NCSX Modular Coil Assembly Fixture (MCAF) Reference Design Design Update and Response to Information Meeting Questions

Figure 1.0-1 Reference Design Modular Coil Assembly Fixture

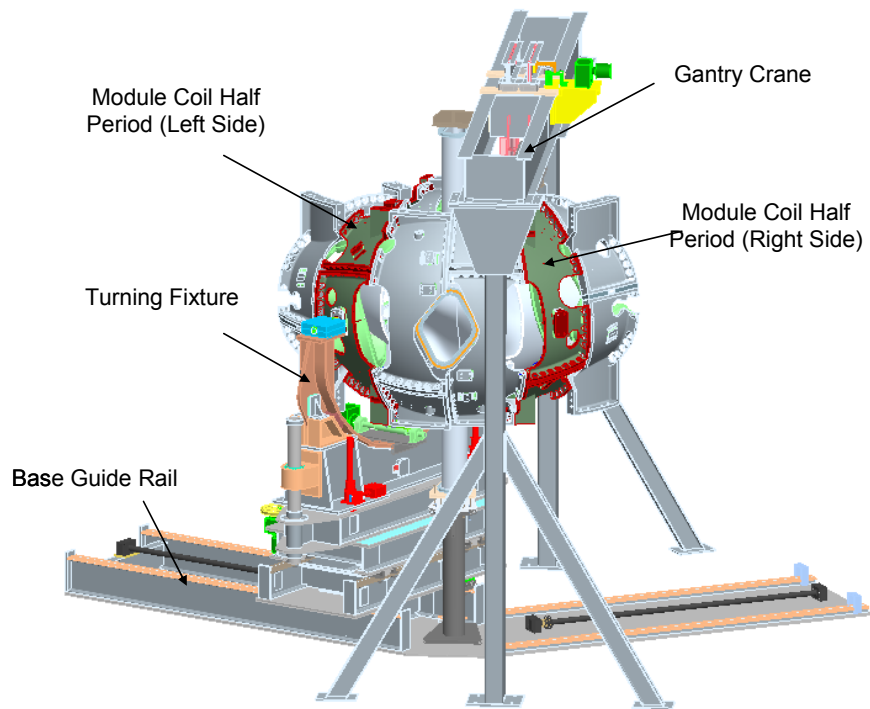
1.0 Turning Fixture: The Reference design (see Figure 1.0-1) has been updated in four areas: 1) in order to provide the same motion of the Turning Fixture from the left side the 6.125" x-axis offset was eliminated and an I-beam was added to the left side base guide rail, raising the vertical placement position for the left side Turning Fixture; 2) two of the Turning Fixture linear support structures were resized to provide greater stability; 3) the interface between the turning fixture and the gantry crane has been further developed and 4) preliminary concept models were developed to evaluate bolt access to the installed MCHP's. Figure 1.0-1 shows the final configuration for the MCAF where MCHP's are supported from the gantry crane on the right side and off a repositioned Turning Fixture on the left side.

Figure 1.1-1 Turning Fixture Reference Axis

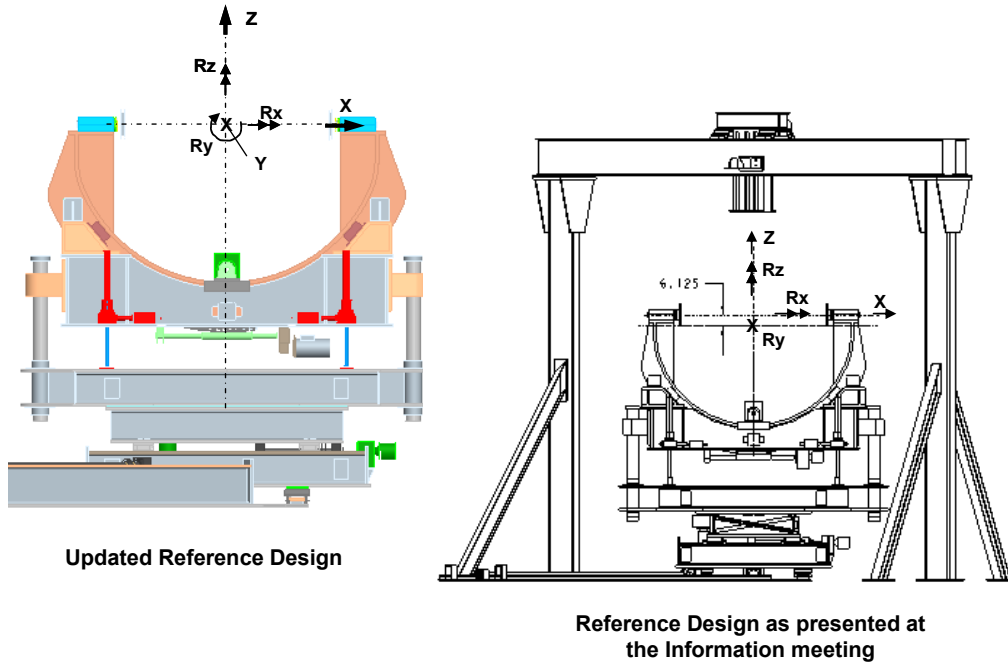
- 1.1 **X-Axis Offset:** To retain the same motion on the left side the 6.125” offset of the x-axis from the machine coordinate centerline has been eliminated. This was accomplished by expanding the overall width of the turning fixture and reducing the height of the gimbal structure. A comparison of the change in axis is shown in Figure 1.1-1.

Figure 1.2-1 Motion of MCHP on Left and Right Side

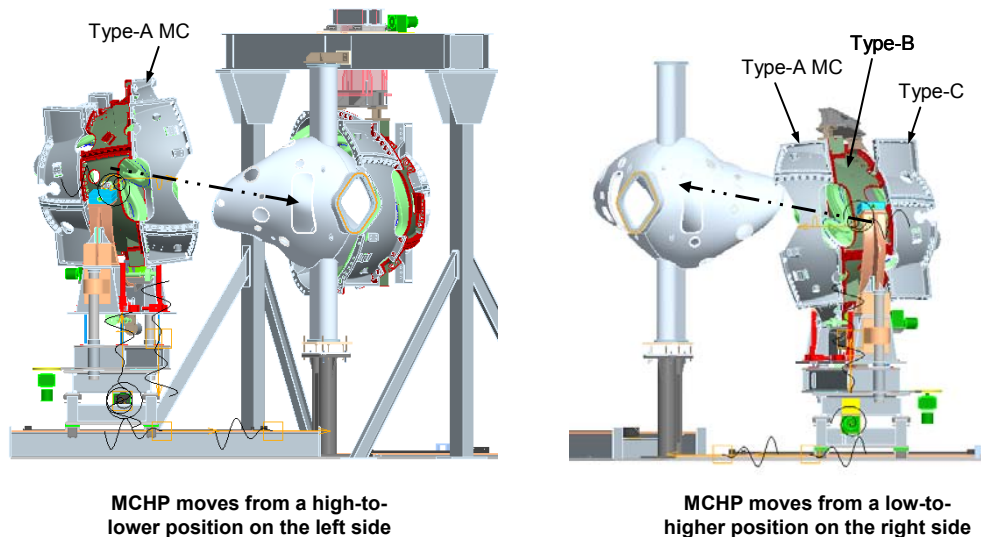
- 1.2 **Base Guide Rail Revision:** An I-beam was added to the left side of the base structure to raise the placement position of the Turning Fixture. This enables the jack screws providing z-direction motion to be sized to provide the minimum vertical lift needed to raise the MCHP from either the right or left side. It should be noted that the vacuum vessel shell geometry forces the MCHP to move from a low-to-higher position on the right side and from a high-to-lower position on the left side (see figure 1.2-1).

Figure 1.3-1 Turning Fixture Reference Axis

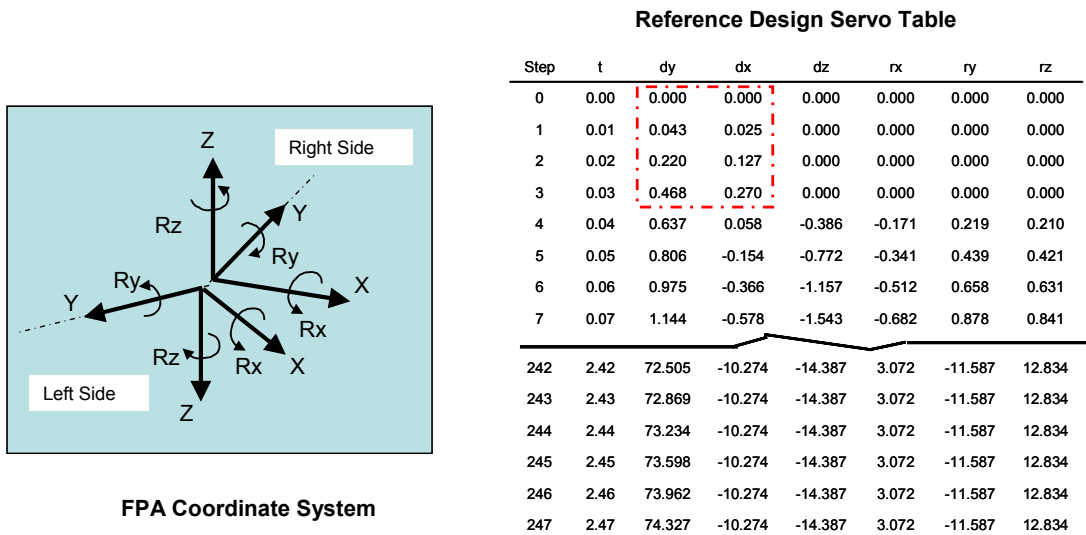
1.3 Coordinate System: With the revision in the x-direction offset and the addition of an I-beam on the left side the coordinate system that defined the MCHP path on the right side could simply be rotated about the Machine Coordinate System x-axis, allowing one servo table drive system to operate both the left and right side. Figure 1.3-1 shows the relationship between the left and right coordinate systems and the Reference Design 247 step servo table. For clarification, it should be noted that the servo table is set up to “disassemble” a MCHP over the vacuum vessel. We have defined the starting position on the servo table (Step 0 – all values are at 0) as the position where the MCHP is located when the left and right sides are bolted together (their final position). Step 3 is the position where the MCHP is beneath the gantry crane ~ 0.54” from the final position (Step 0). The phantom box in the servo table indicates that only motion in the y and x direction occurs during Steps 1 thru 3, allowing the MCHP to move perpendicular to the interface parting plane between the left and right hand MCHP’s. Step 247 defines the position where the MCHP Type-A MC will start to pass over the vacuum vessel (moving toward the gantry crane, see Figure 1.2-1). Additional steps beyond Step 247, that will move the MCHP to a position at the end of the guide rail, have not been added to the servo table at this time.

Figure 1.6-1 Resized Linear Support Structure

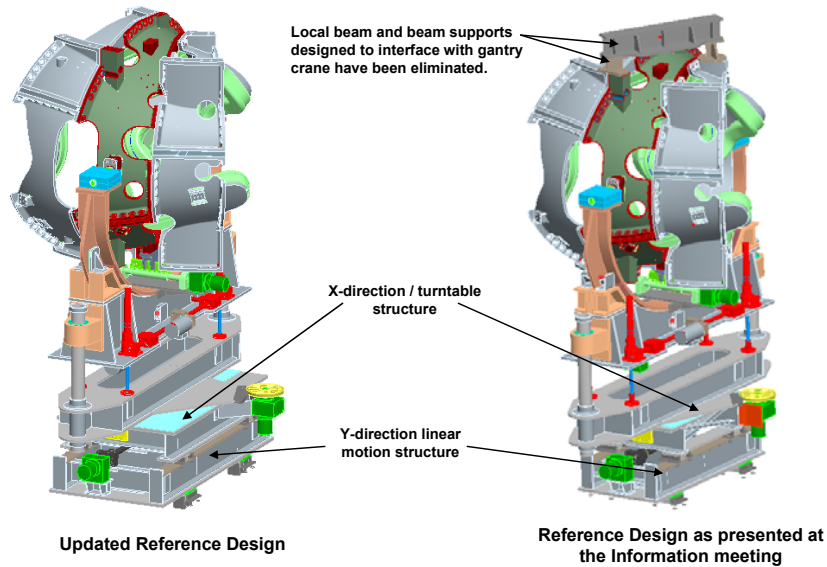
1.6 Resized Linear Support Structure: To improve the stability of the Turning Fixture against seismic and sudden stop conditions the first two support bases of the Reference Design were enlarged in the y-direction of motion (see Figure 1.6 -1).

Figure 2.0-1 MCAF Gantry Crane

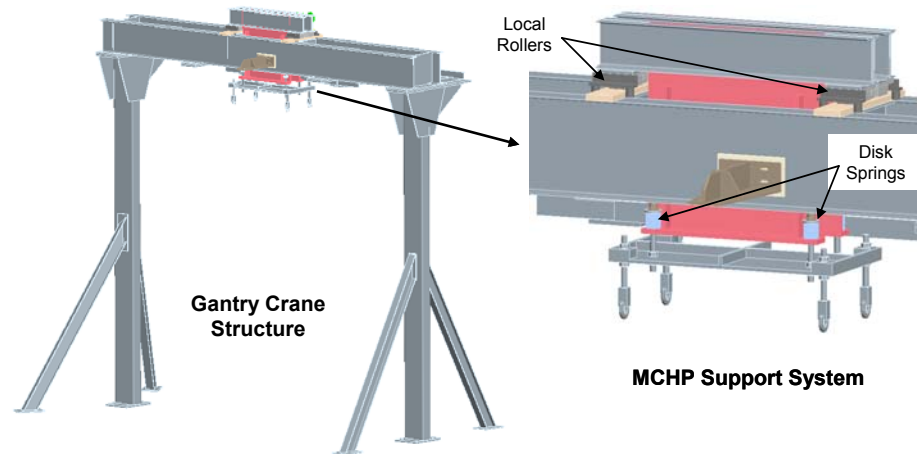
2.0 Gantry Crane: The Reference design gantry crane serves two purposes: 1) it supports the right side MCHP when it is ~ 1/2" from the final position (moving from step 247 to step 3 in the Ref servo table listed in Figure 1.3-1); and 2) it provides support to a linear mechanism that moves the right side MCHP into its final position (~ 1/2" of linear motion). Because of the geometry of the Type-A MC the MCHP's would interfere with each other if we were to simply place the right side in its final position and then manipulate the left side to reach its final position. With the right side supported off the gantry crane, the left side can be moved to its final position (reusing the turning fixture); then the right side can be moved to its final position using the local mechanism that is mounted off the gantry crane. The Reference design gantry crane has been updated to better define the MCHP attachment method and to identify service access for attaching the MCHP to the crane and bolting the MCHP's together. Figure 2.0-1 highlights the latest arrangement of the gantry crane showing an updated MCHP support system.

Figure 2.1-1 Gantry Crane / MCHP Interface

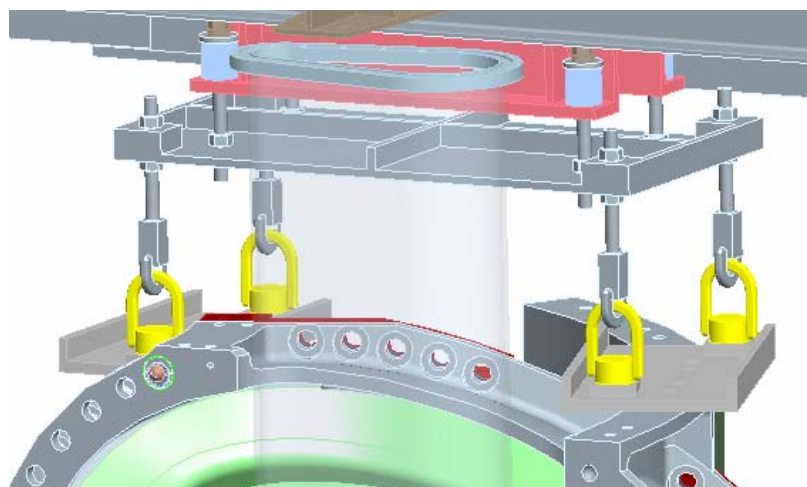
2.1 MCHP / Gantry Crane Attachment Method: The Specification document reviewed at the information meeting called out a requirement to limit the vertical deflection of the gantry crane to .050" inches (defining a relatively stiff system). When the MCHP is transferred from the turning fixture to the gantry crane there can be no interference with the vacuum vessel insulation system due to deflections of the gantry crane. Contrary to this "stiffness" requirement there is a desire to have some degree of "float" in the support of the right side MCHP support (off the gantry crane) in an

effort to aid the seating of the two MCHP's as the gantry crane mechanism moves the right MCHP to its final position, engaging the left side MCHP. Figure 2.0-1 and the local view of Figure 2.1-1 shows the approach used in the Reference design for interfacing the gantry crane with the MCHP. The MCHP is supported off four links that span the CG of the MCHP. Relatively stiff disk springs have been added to provide some additional "float" to the support system to increase the allowable deflection of the system to ~ 0.10 ". The evaluation of the support method and final specification of the allowable deflection is under internal review.
